SITE/SOIL EVALUATION FOR ON-SITE WASTEWATER

lot 22

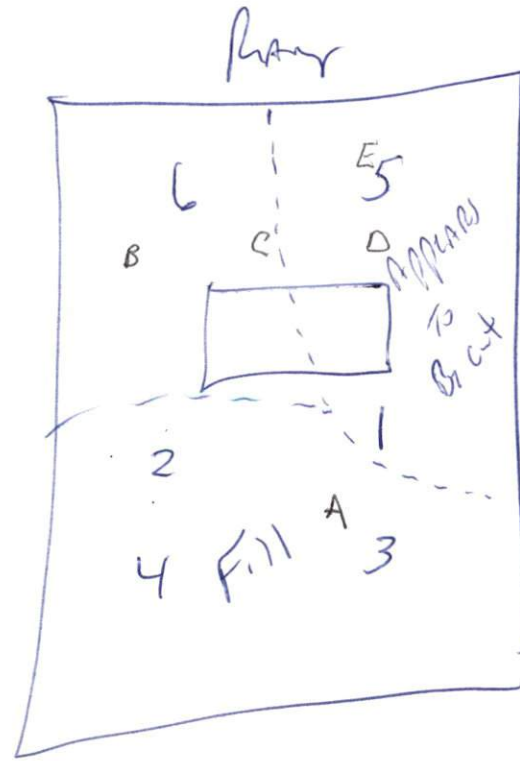
Refer to
O.T. will
Need P.T.s
for AREA 4
Fill

Hole
APPEARS
To Be mixed
Soils from either
cutting or Filling

- A
CR2 @ 20"
- B
CR2 @ 24"
- C
FILL 5"
CR2 @ 36"
- D
FILL 21"
CR2 @ 40"
- E
FILL 48"
